▲ = Revised November, 1995

**No. 93-14**

## Weber 4 Barrel Carburetor

### Adjustable Accelerator Pump

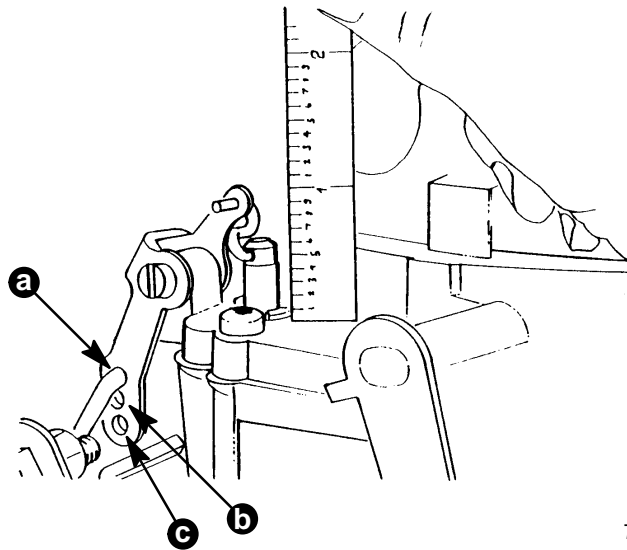
The accelerator pump lever has three holes in it. The closest hole to the lever's pivot point is the richest, the second hole is leaner and the hole farthest away is the leanest. All production carbs have the pump rod installed in the closest (richest) hole. If you are having a "rich" bog on acceleration, move the rod to the second or third hole. Weber put the three holes in the lever so the amount of fuel delivered by the accelerator pump could be changed.

- a - Richest
- b - Leaner
- c - Leanest

### Choke Pull-Off Specification Change For All V6 and V8 Engines

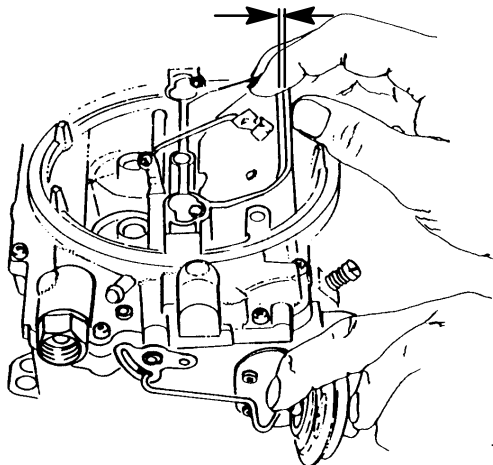
Whenever servicing one of these engines or if your customer is experiencing an overly rich running condition after first starting the engine, please reset the Choke Pull-Off to this new specification.

V6 & V8 305, 350 cid: 3/16 in. (4.5 mm)
V8 454, 502 cid: 15/64 in. (6 mm)

## MCM/MIE 7.4L Main and Secondary Jet Change

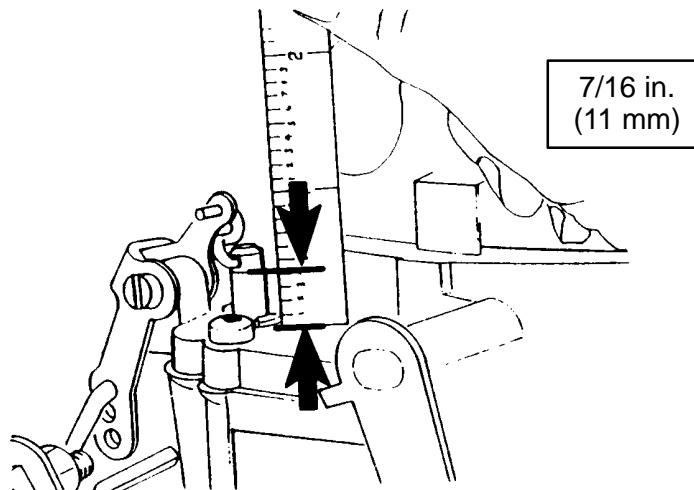
If you have a rich running engine at idle or one that surges above 4000 RPM or it has a backfire at 2400-2600 RPM, change the main and secondary jets. Engines above the serial numbers listed have the jets already changed to the new sizes.

(2) 811541 .107 in. Main Jets

(2) 811542 .098 in. Secondary Jets

## Initial Setting For Idle Mixture Screws

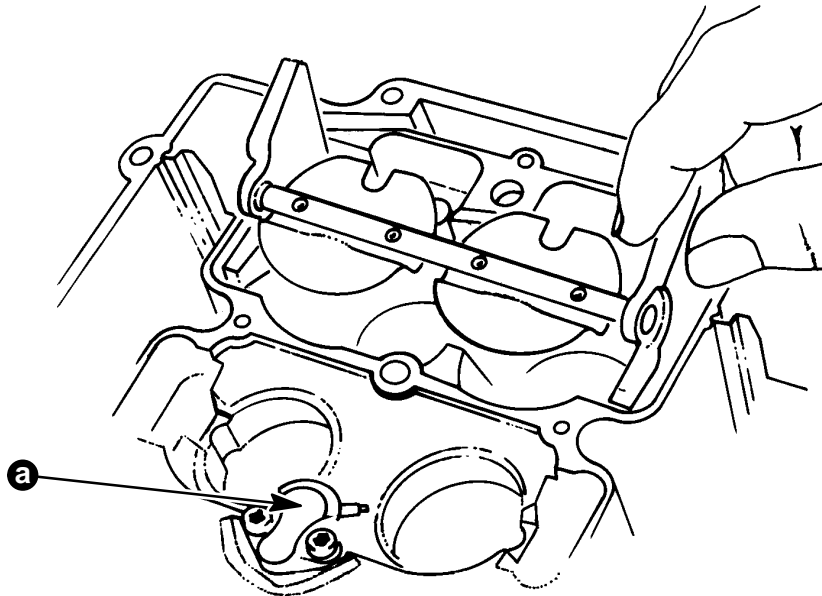
The initial idle mixture screw setting for all Weber carburetors should be as shown below. All Service Manuals will be updated.

1-1/4 to 1-1/2 Turns Out From Seat
